From:	Aaron Coon
To:	Hubbard, Sam
Cc:	Perkins, Charles; Recklaus, Randall; Hayes, Thomas
Subject:	Re: PC - Arlington 425
Date:	Wednesday, March 31, 2021 3:31:43 PM

HIGHLAND PARKING GARAGE WEST ELEVATION

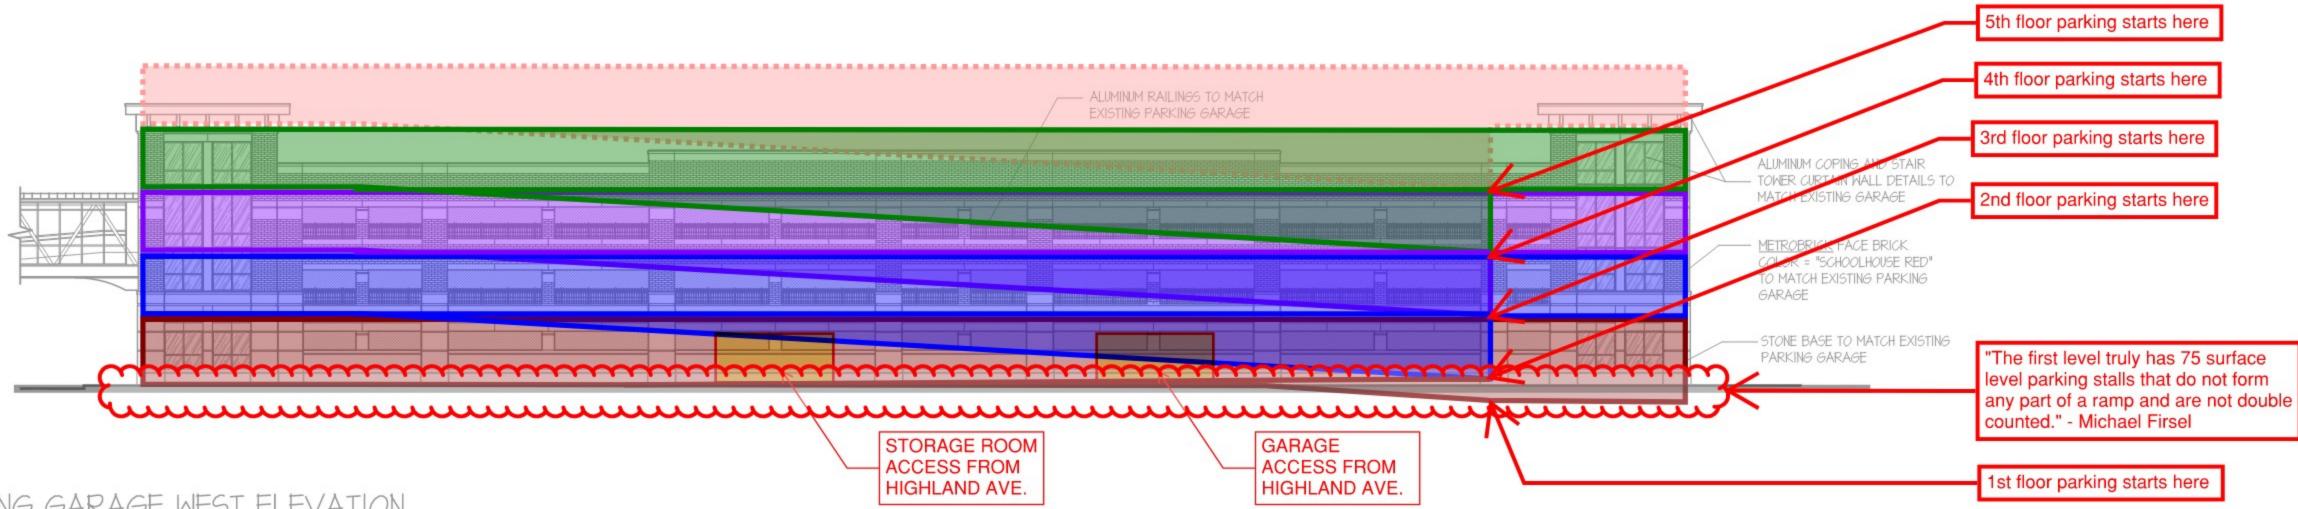
In the response letter with the parking level diagrams, Michael Firsel stated that the first level truly has 75 surface level stalls that do not form any part of a ramp and are not double counted. My question is, in a garage that is 123 feet by 247 feet, how is it possible to fit 75 cars on the level parking surface and not have any cars within that count located on a ramp up to the 2nd level? Where is the ramp from the 1st level to the 2nd level located and how does it provide vehicular access to a full 2nd floor that is 123 feet by 247 feet with 91 parking stalls? The level 1 plan shows the ramp beginning in the west bay at the north end of the deck. However, the level 2 plan shows a ramp going down to level 1 from the east bay at the north end of the deck.

I've highlighted the west elevation to correlate with the sketch diagram from the petitioner that I believe contains incorrect assumptions of the total parking counts. Please share this with the plan commission members.
